**Rezoning Application:** 23-0848  
**Zoning Hearing Master Date:** April 15<sup>th</sup>, 2024  
**BOCC Land Use Meeting Date:** June 11<sup>th</sup>, 2024

This is a request to rezone a parcel from ASC-1 to Planned Development (PD) in order to construct a warehouse to allow storage, distribution, and contractors office uses.

## AGENCY REVIEW COMMENT SHEET

**SUBJECT: 1102 SE 33<sup>RD</sup> STREET PD (PD 23-0848)**  
**EXISTING FACILITIES DESIGN EXCEPTION**  
**FOLIO No. 055048.0000**

### 2.4 Proposed Site Plan (partial provided below for size and orientation purposes. See Section 8.0 for full site plan)

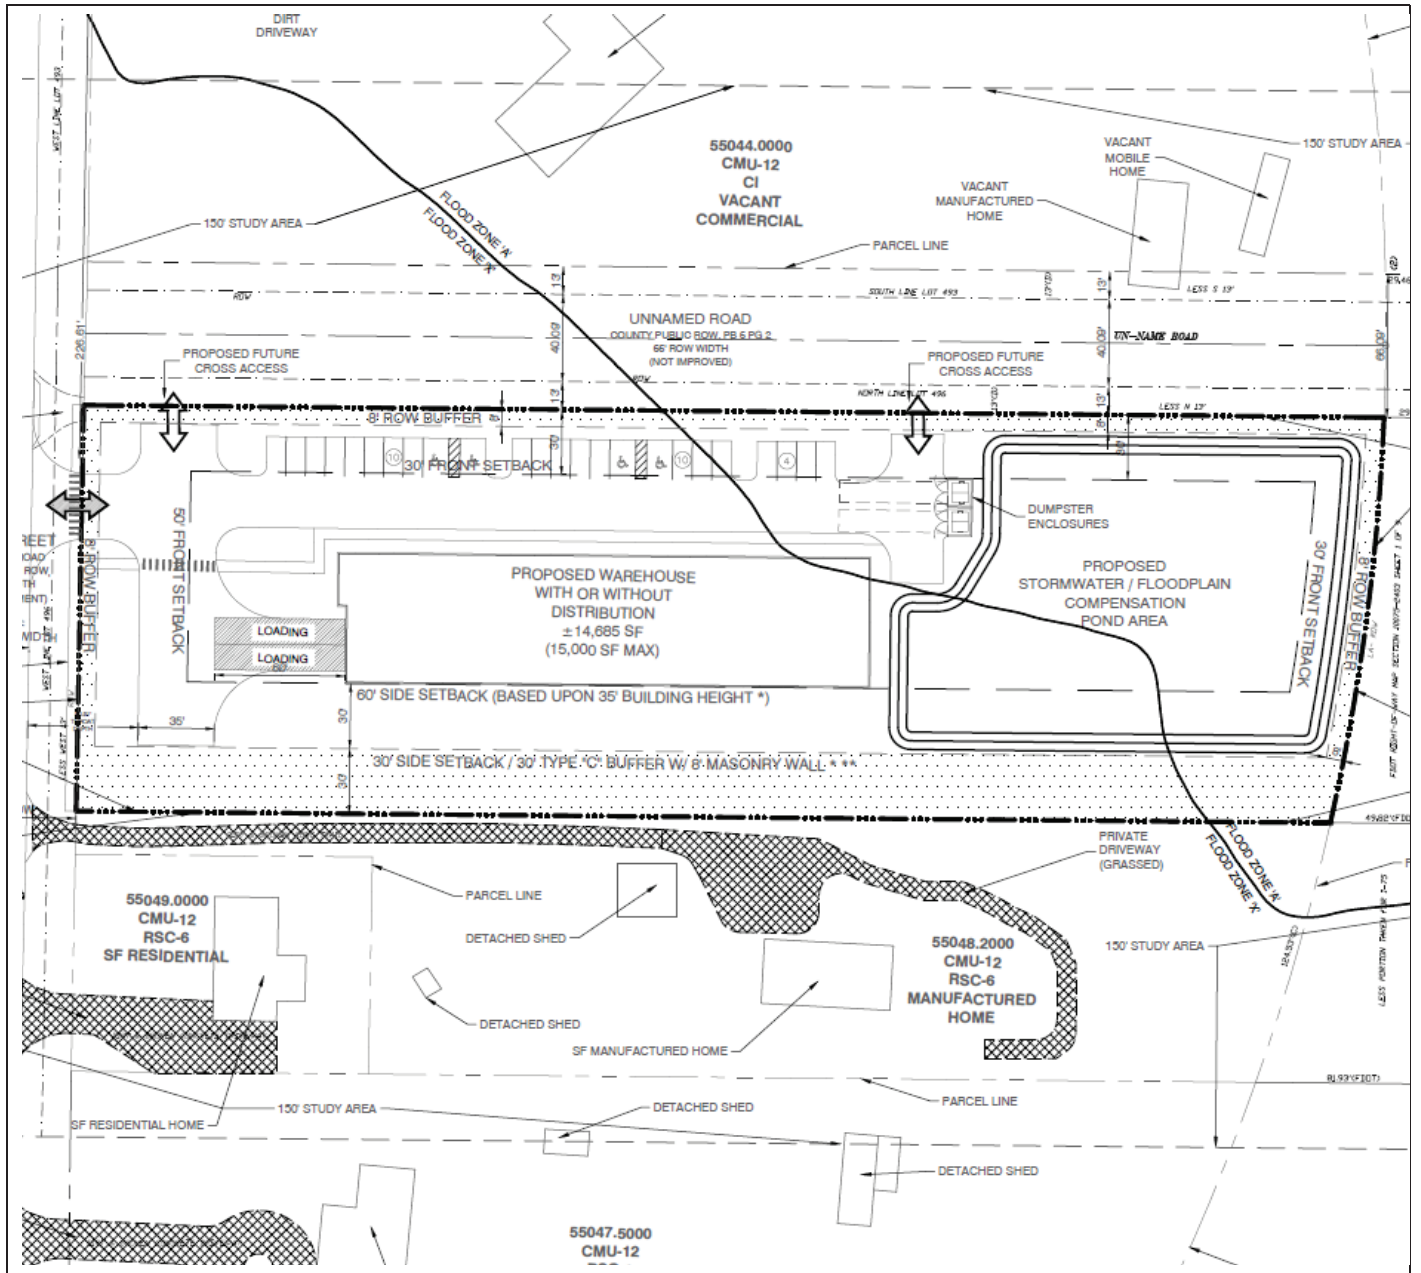
1. Remove the two Proposed Future Cross Accesses from the site plan and update the legend; and,
2. Remove the label reading "Proposed Future Pedestrian and Vehicular Access" which is shown along the southern boundary.

- Prior to PD site plan certification, the applicant shall revise the site plan to:
  - Remove the two Proposed Future Cross Accesses from the site plan and update the legend; and,
  - Remove the label reading “Proposed Future Pedestrian and Vehicular Access” which is shown along the southern boundary.

the applicant’s representative on March 28, 2024 to discuss issues pertaining to the proposed future cross access on the northern property boundary, and the applicant agreed to a zoning condition requiring remove those potential cross access connections as a “Prior to Certification” condition.
